Type Coffee Vending Machine	Model 95	N° T.I. 02 - 2023
Serial Number 22120630	Subject LEAD FREE MACHINE	ISSUED FOR (X) Action Information X

A *lead-free* version (code **975821**) was introduced, derived from the existing *95 machine* (code 975803).

Lead - free Assembly Boiler Spare
code: **265326/55126243**

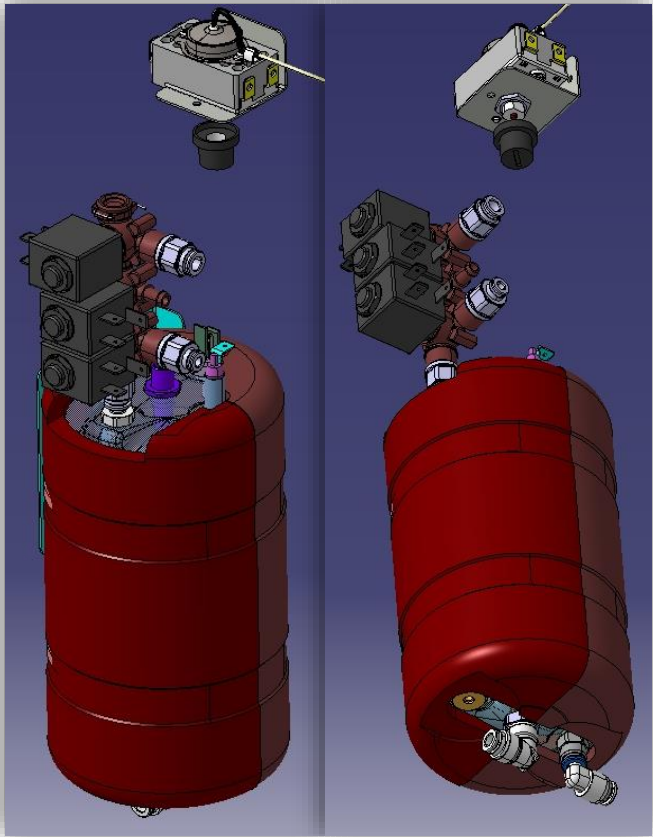
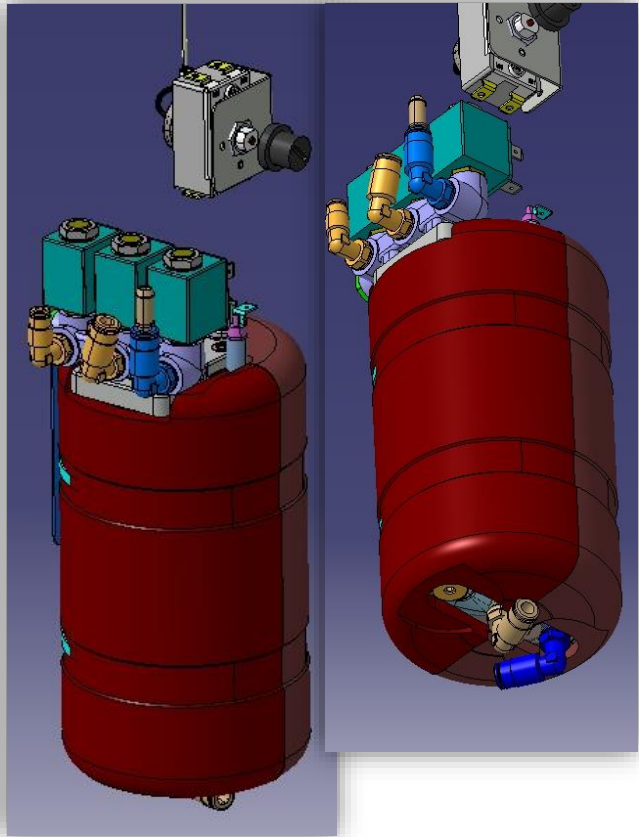
Not lead - free Assembly Boiler
Spare code: **261906**

1 *Lead-free (Plastic) solenoid valves*
Spare code: **265325/55126241**

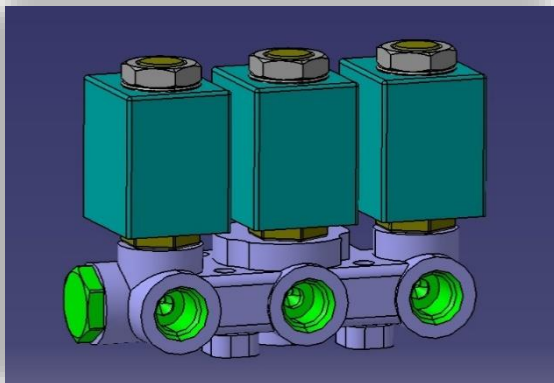
1 *Not lead-free solenoid valves*
Spare code: **259911**

Fittings on Solenoid valves

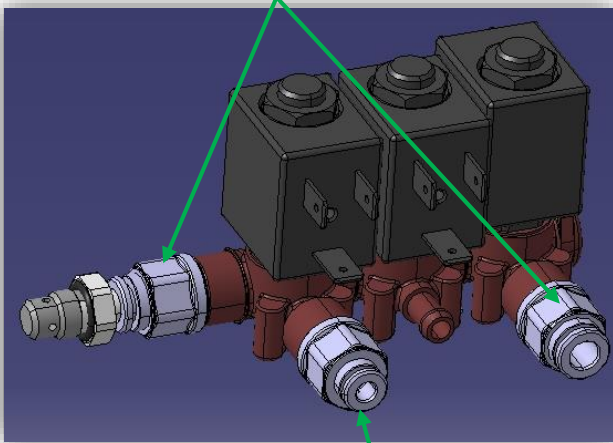
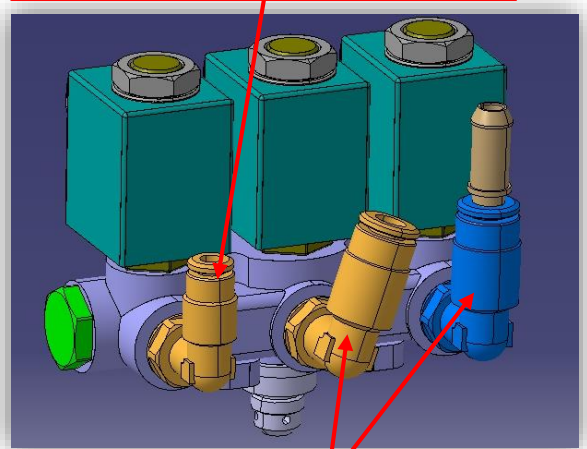
G1/8 Ø6 Straight quick Fitting
Spare code: **263425 / 55124199**

Teflon Ø4-G1/8 PPS connection
Spare code: **264387 / 55124115**

L Rotating with OR 4-1/8 unleaded
Spare code: **256273**

L Rotating with OR 6-1/8 unleaded
Spare code: **256280**

3 *Plastic Non return valve + By_pass*
Spare code: **262764 / 55126242**

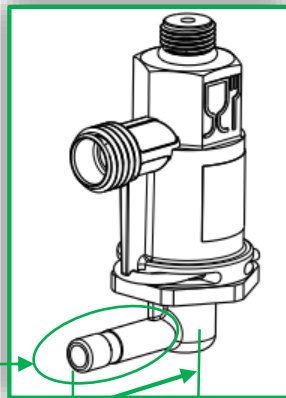
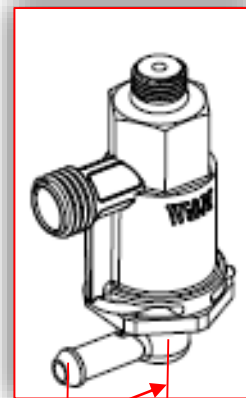
Modified Outlet profile

D_{new}

3 *Still used on: 975803*
Spare code: **257729**

D_{standard}

Fittings on Boiler

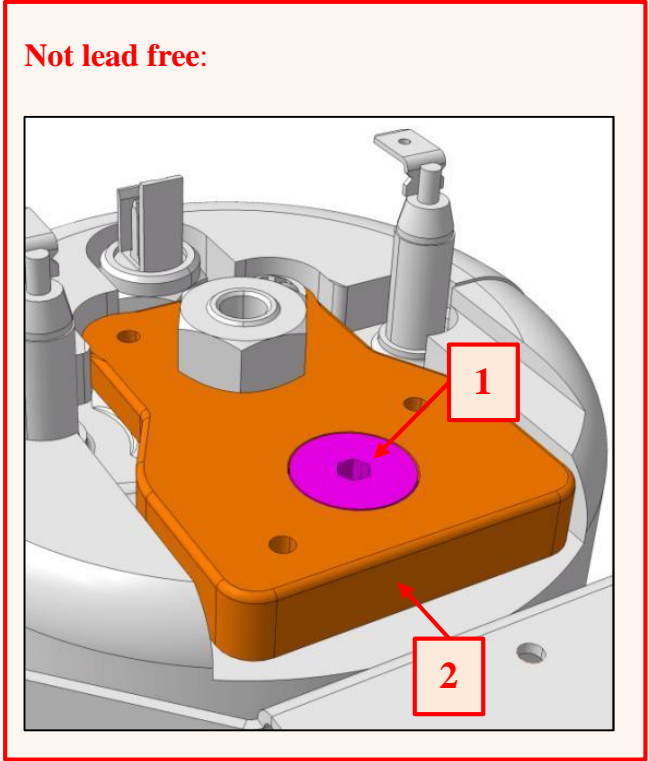
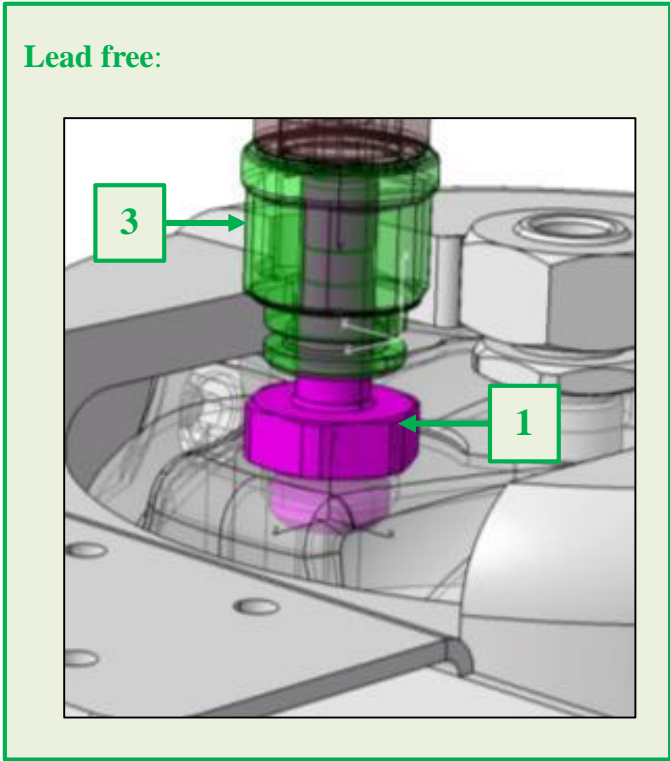
Description	Spare Code
1 Boiler outlet fitting	264384 / 55124112
3 Straight fitting for teflon-6	263425 / 55124199

Description	Spare Code
1 Boiler outlet fitting	261358
2 Inductive plate	257343

IN / OUT BOILER

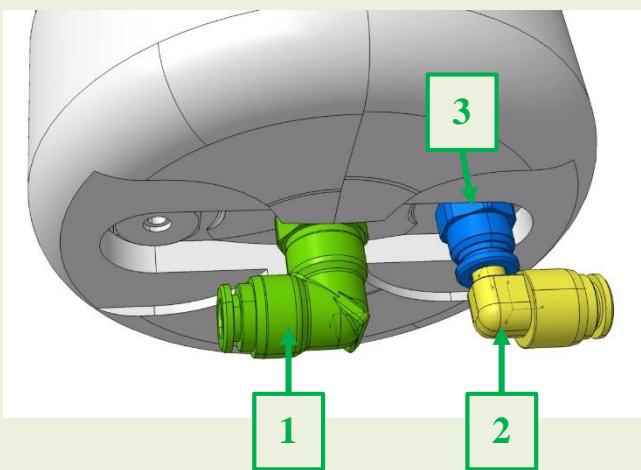
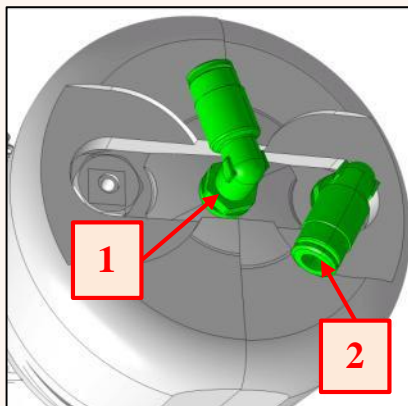
Description	Spare Code
1	Tube swiveling fitting for teflon-6 (boiler inlet)	264385/ 55069196
2	Swiveling fitting for teflon-6 (boiler drain)	263427/ 55124250
3	Straight fitting d.6 inox	264386/ 55124114

Description	Spare Code
1	Tube swiveling fitting for teflon-6 (boiler inlet)	258904
2	Swiveling fitting for teflon-6 (boiler drain)	256280

EV Z4000 –ES/FB

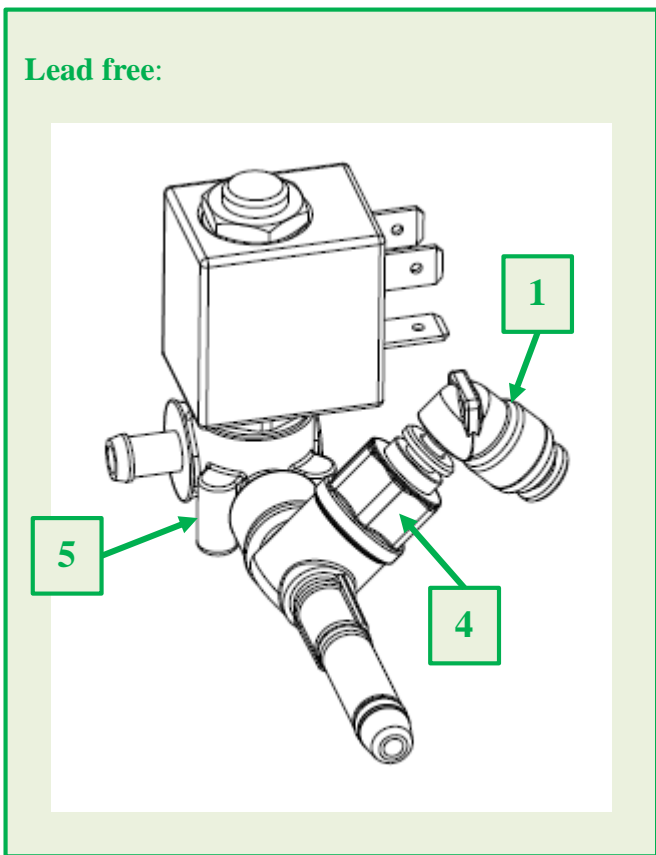
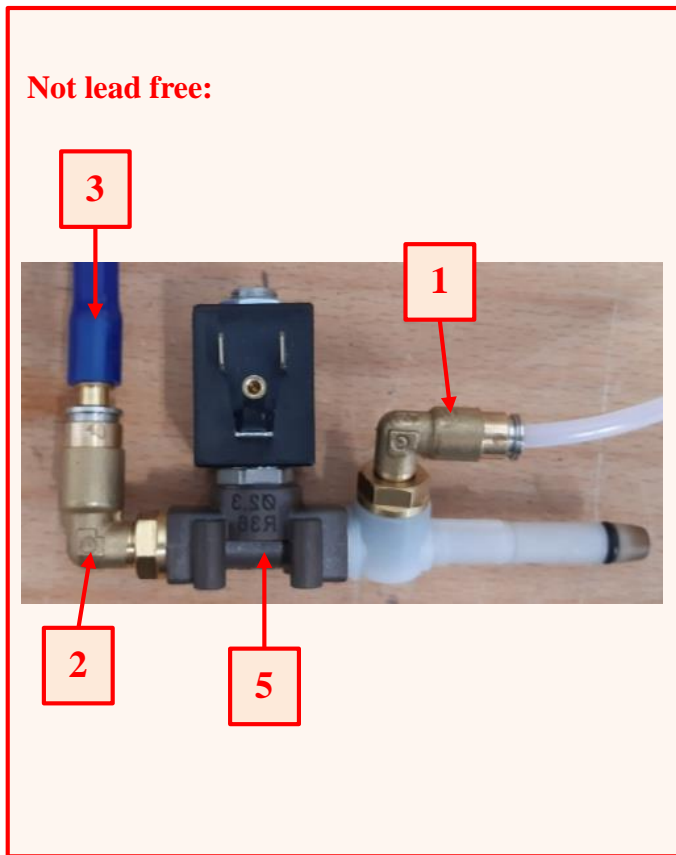
Description	Spare Code
1 L-swiveling for teflon-4	264388/55124116
4 Straight fitting for teflon-4	264387/55124115
5 EV	264390/55124118

Description	Spare Code
1 L-swiveling for teflon-4	256273
2 Swiveling fitting for teflon-6	256280
3 Teflon / silicone adapter	258914
5 EV	258764
